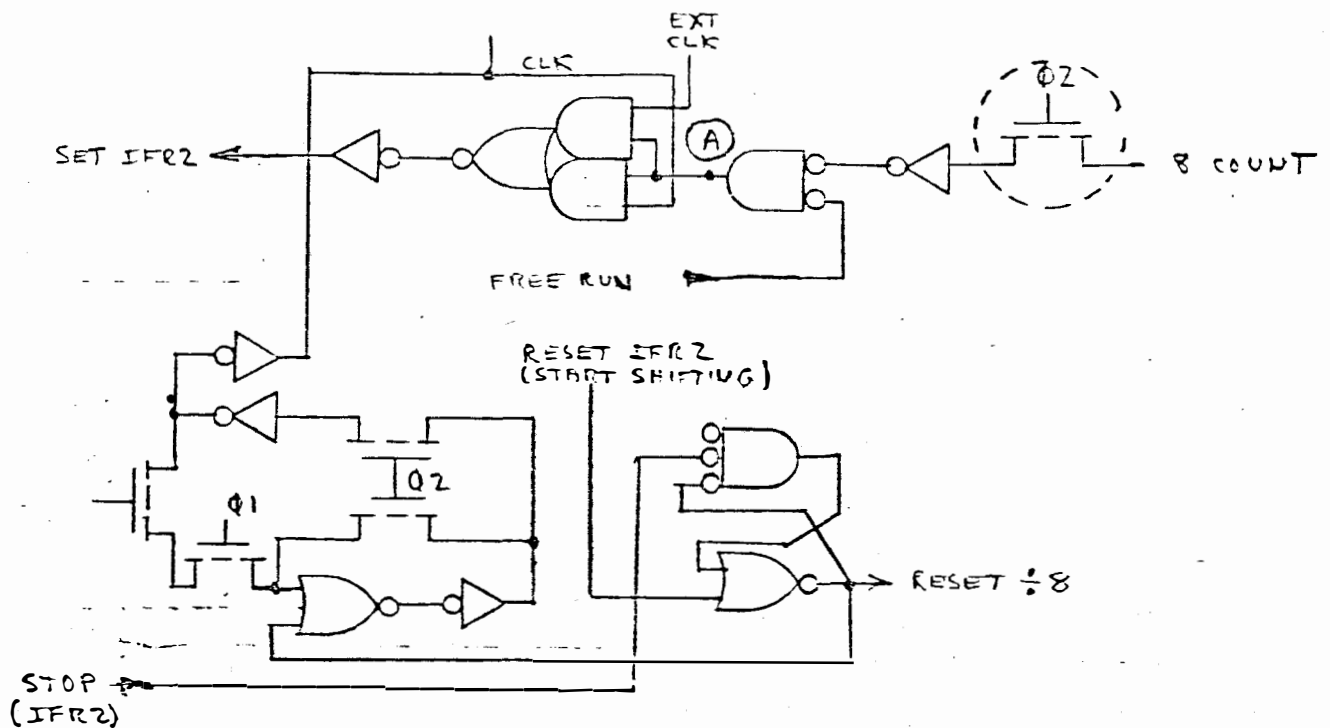
- ① PROBLEM: NINE CLOCK PULSES ARE OUTPUTTED WHEN SHIFTING IN AT THE SYSTEM CLOCK RATE, HOWEVER, THIS IS NOT THE CASE WHEN SHIFTING OUT,
